**RESOLUTION NO. 2024-100
VILLAGE OF CALEDONIA**

**A RESOLUTION APPROVING A CONCEPT PLAN FOR THE PROPOSED THOMAS
FARM SUBDIVISION TO ESTABLISH THE BASE DEVELOPMENT YIELD AND
DENSITY AND TO APPROVE THE WAIVERS OF ORDINANCE 14-3-4(c)(4)(b)(ii)
AND 14-3-5(b) ON PARCEL ID NUMBERS
104-04-23-17-077-000 AND 104-04-23-17-081-000**

PLAN COMMISSION REPORT

MEMORANDUM

THOMAS FARM- CONCEPT SITE PLAN

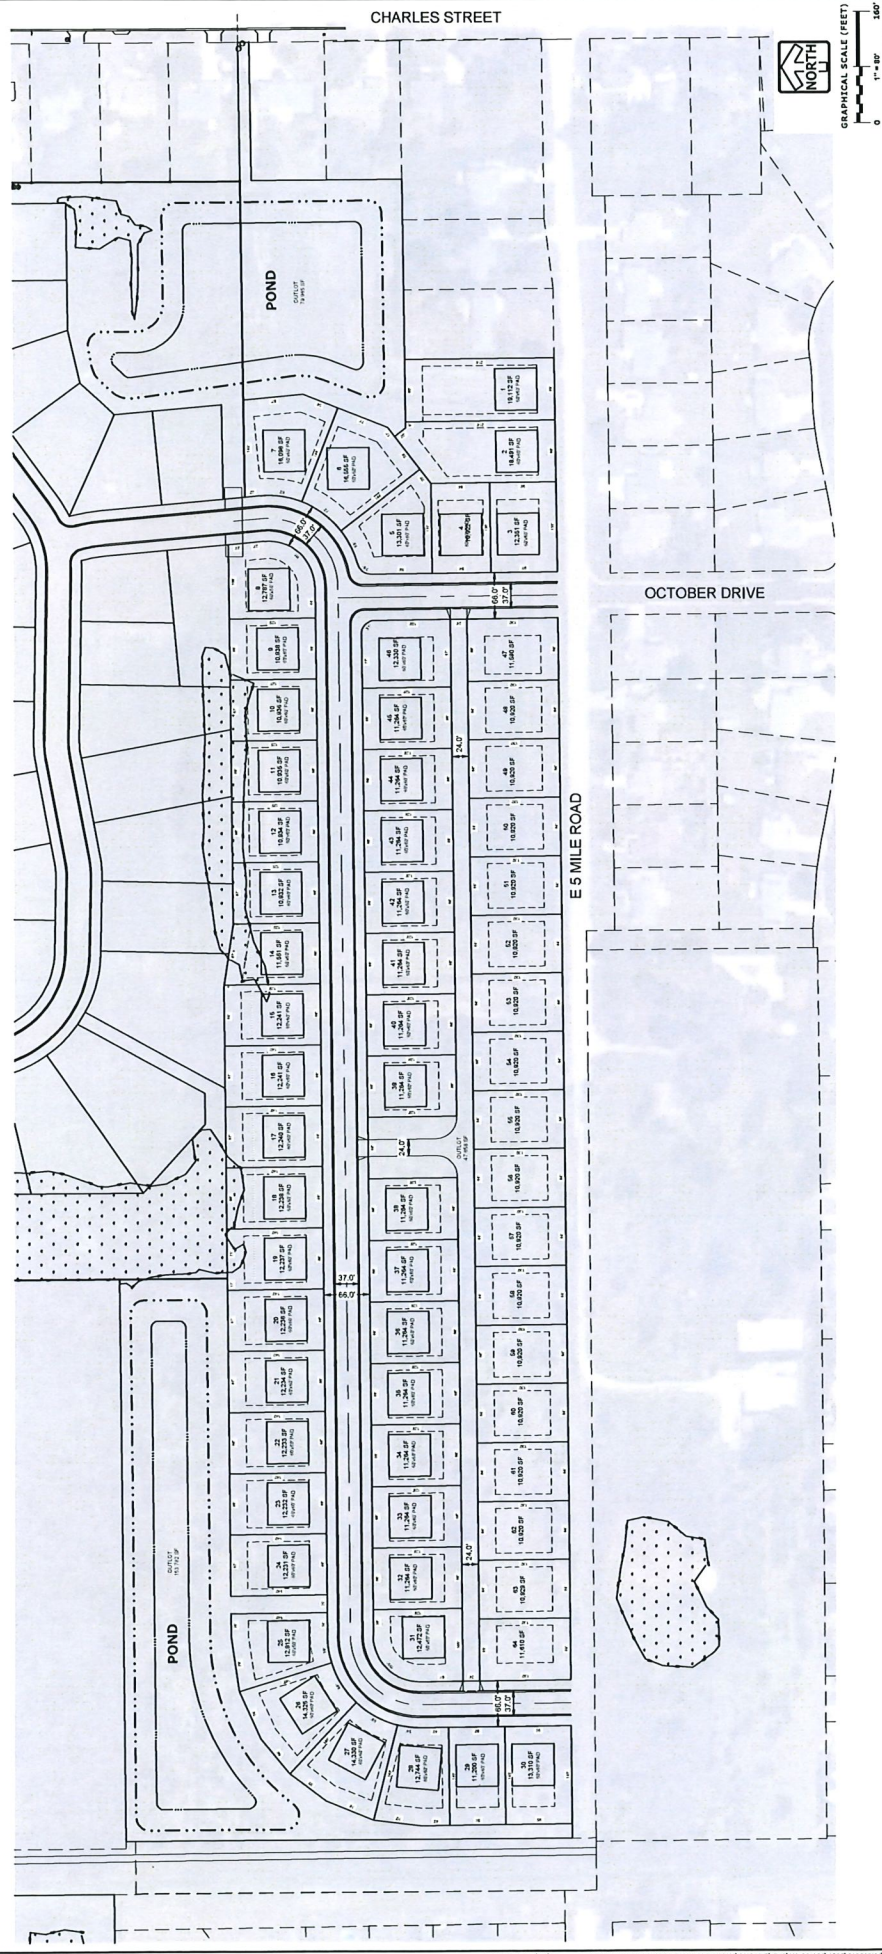
The Concept Subdivision Plan proposes a 64-lot residential development with three Outlots—two designated for stormwater ponds and one containing a private alley. The plan also includes a dedicated 66-foot Village right-of-way for two local urban subdivision roads. Additional right-of-way dedication will be required for the installation and extension of 5 Mile Road across the Klema Ditch. The combined size of the subject properties is approximately 27.64 acres. These properties are currently unimproved and actively farmed for row crops and nursery stock. Additionally, the subject properties include a "gap" in 5 Mile Road. The Concept Plan and Cover Letter are included as Exhibit B.

Open Space: The ordinance requires 40% Open Space, but the proposed subdivision provides only about 19%. This does not meet the 40% Open Space requirement outlined in Sec. 14-3-4(c)(4)(b)(ii) of the Municipal Code. However, the subdivision is located within the Sewer and Water Service Area, where previous applications have been approved with less than 40% Open Space. A Modification Waiver from Ordinance 14-3-5(b) will also be necessary, allowing the subdivision to develop without Conservation Easements—a waiver that has been granted for other subdivisions in the Sewer and Water Service Area. The Planning and Engineering Departments support granting these Modification Waivers as detailed below:

A Certified Survey Map (CSM) is recommended to dedicate the 5 Mile Road Right-of-Way, resolve legal description gaps, and dedicate future utility easements. The 5 Mile Road must be constructed and fully extended to meet Village standards, ensuring the lots meet the frontage requirement. Sewer lines will need to run through a dedicated easement or road reservation south through the Thomas Farm Property along the North Meadows Drive Right-of-Way extension (not included in this Concept Plan). Water lines will need to be looped throughout the subdivision, while remaining separate from the pressure zone west of the Klema Ditch. Additional details have been provided in Exhibit A.

Access: The Applicant proposes to dedicate a 66-foot Right-of-Way for local subdivision roads and to complete 5 Mile Road across the Klema Ditch. The Concept Plan includes two access points onto 5 Mile Road, which is designated as a principal thoroughfare in the Village of Caledonia. To match the existing 5 Mile Road sections to the east and west, a 70-foot Right-of-Way will be required. Additionally, an access point will be established to the north to connect with the preliminary plat of Audubon Arboretum.

To minimize driveway entrances on 5 Mile Road, lots 47-64, which front 5 Mile Road, are proposed to have alley-loaded garages. Attached garage structures must fit within the buildable footprint of each lot to comply with the proposed zoning. The private alley, which will be within an Outlot, will

be owned and maintained by the HOA and must be capable of supporting garbage and fire truck traffic. No access must be shown along the entire frontage of lots 47-64 on 5 Mile Road.

Environmental: The subject properties include WDNR-delineated wetlands, located primarily along the northern portion of the site. These wetlands will be contained within one of the proposed Outlots designated for a stormwater pond and will also be present in the rear yards of 10 of the proposed lots. Disturbance of these delineated wetlands is prohibited unless approved by the DNR. It is recommended to adjust the lot layout along the northern boundary to minimize the impact on the wetlands on each lot. There are no Primary or Secondary Environmental Corridors on the property as identified by SEWRPC.

11. The Developer resolves the gap in legal descriptions along the borders of this parcel.
12. The Developer resolves the lot line issue along Lots 8-19 which includes lands from the proposed Audubon Arboretum via CSM or other means.

13. The Developer dedicates a minimum 70' Right-of-Way for 5 Mile Road and aligns it appropriately across the Klema Ditch to the West to resolve the offset centerlines.

14. No Access Restrictions are applied to Lots 3, 30, and 47-64 along 5 Mile Road and 50' in each direction at all intersections.
15. The Developer provides 25'x25' Vision Triangle Easements at all intersections and 15'x15' Vision Triangle Easements at the alley access intersections.

16. The Developer shall review Lots 9-15 and 17-19 to either mitigate the wetlands from the buildable footprint of the lot or alter the lots to avoid the wetlands.

THOMAS FARM- LAYOUT

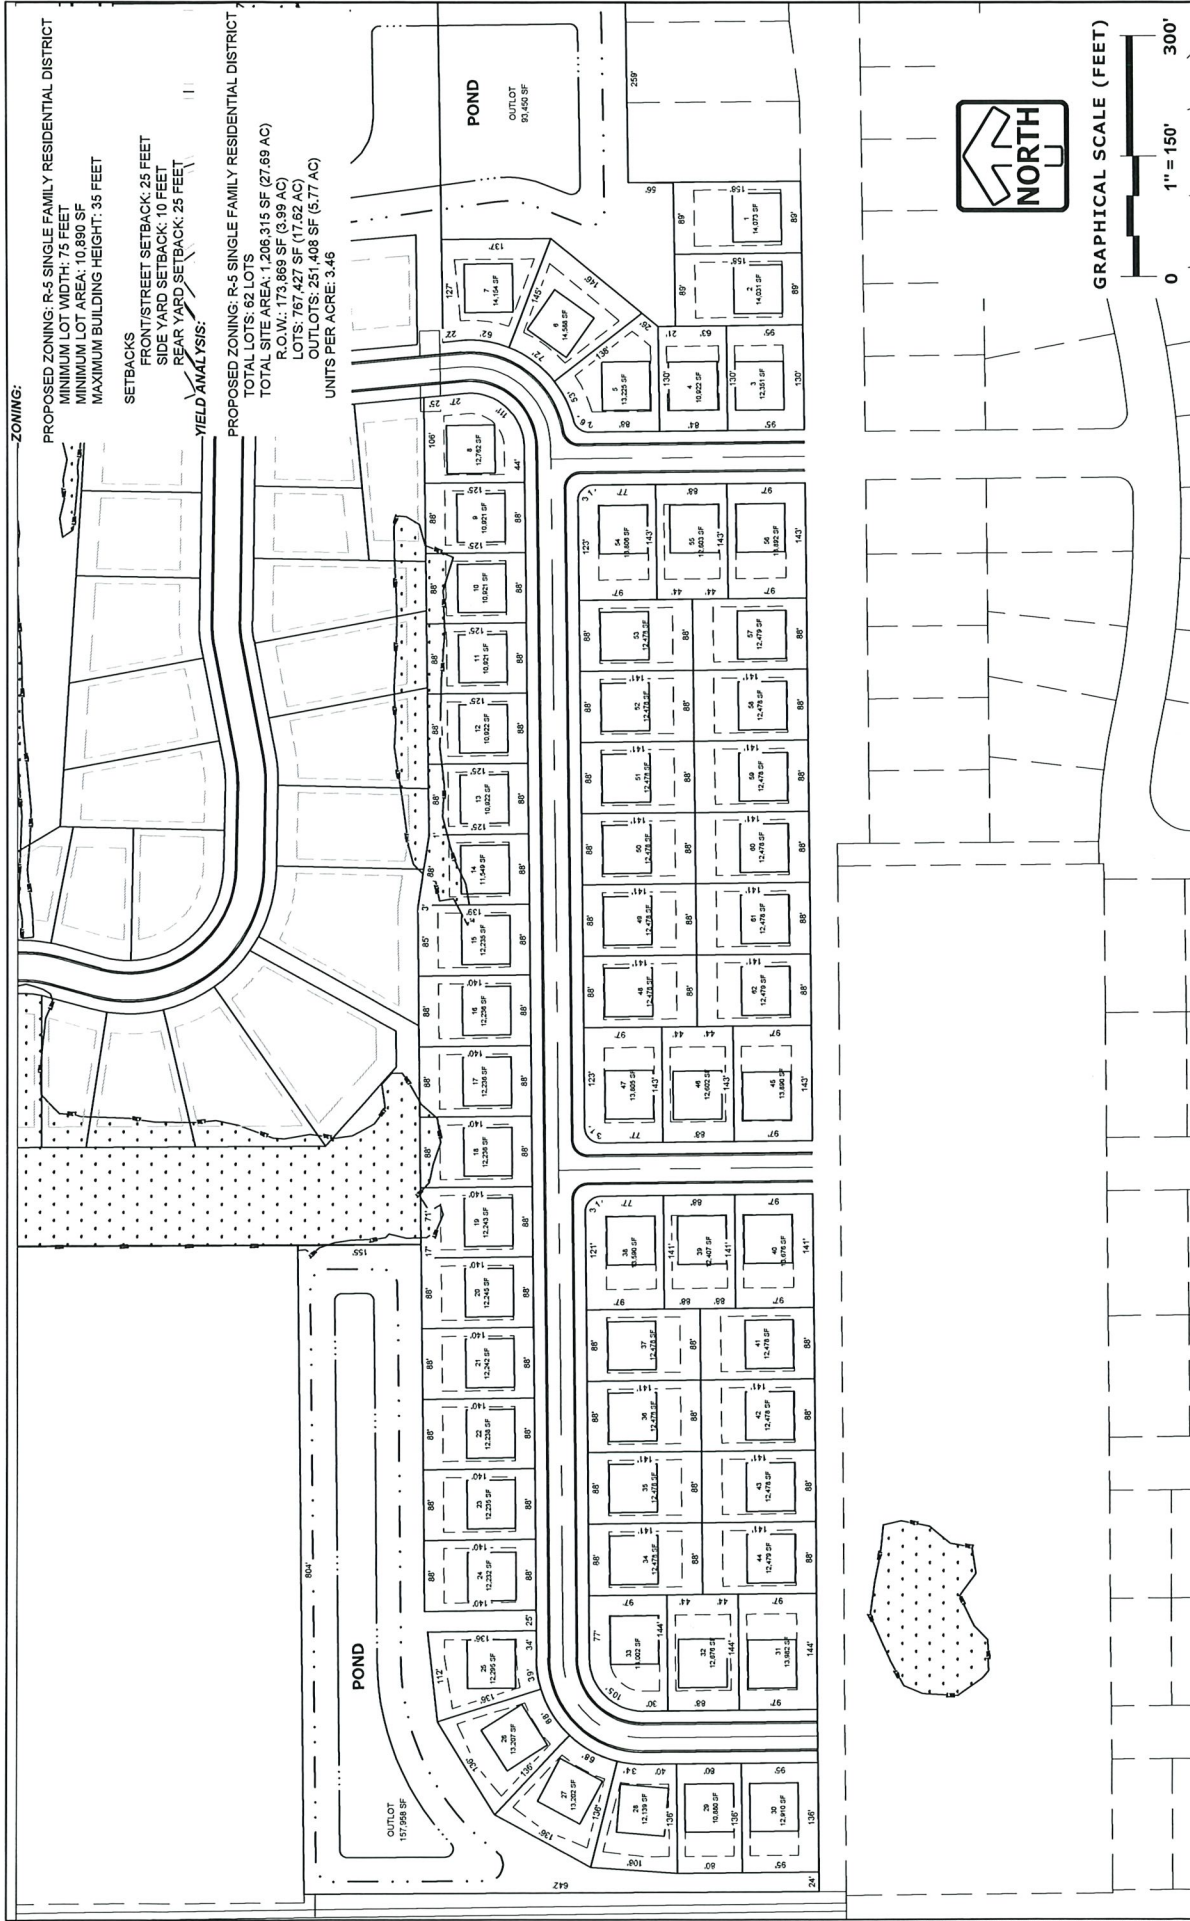
The Plan Commission tabled the Thomas Farm Concept Plan on August 26, 2024, and requested the developer to amend the Concept Plan to include Plan Commission and Resident feedback. The updated and attached Concept Plan, included as **Exhibit B**, has the same conditions as the Plan Commission Report dated 8-26-2024 with the following changes and modifications:

- Reduced from 64 to 62 proposed lots.
- Removed the alley and added a new public road extension to load homes off interior street.
- Increased average lot size to 12,378 sq. ft. and primary frontages along 5 Mile Road to be like the neighbors across the street.
- Updated the Density to 3.46 Units per Acre.
- Updated the Open Space to 21% from the original 19%.

Staff still supports the original proposal based on the original PC Report submitted with the Concept Plan on August 26th. Village Ordinance 18-1-4-(d)(3)(b), which discusses Access Control, requires that land lying along principal thoroughfares (such as 5 Mile Road) may be divided into lots, but the frontage must be on a Local Road. This was achieved through the initial submittal by requiring rear loaded lots on a private drive.

The new concept does not fully satisfy the Ordinance as written, but the Developer has worked with Village Staff to limit the number of lots that were given access onto 5 Mile Road as an alternative if the Plan Commission and Village Board disagree with the rear loaded concept.

The Concept Plan has modified the lot numbering so that any reference on the original Plan Commission Report does not accurately reflect the current proposal. The conditions in the attached Exhibit A include the amended lot numbers which will require access restriction from 5 Mile Road.

11. The Developer resolves the gap in legal descriptions along the borders of this parcel.
12. The Developer resolves the lot line issue along Lots 8-19 which includes lands from the proposed Audubon Arboretum via CSM or other means.

13. The Developer dedicates a minimum 70' Right-of-Way for 5 Mile Road and aligns it appropriately across the Klema Ditch to the West to resolve the offset centerlines.

14. No Access Restrictions are applied to Lots 3, 30-31, 40, 45, and 56 along 5 Mile Road and 50' in each direction at all intersections.
15. The Developer provides 25'x25' Vision Triangle Easements at all intersection.

16. The Developer shall review Lots 9-15 and 17-19 to either mitigate the wetlands from the buildable footprint of the lot or alter the lots to avoid the wetlands.
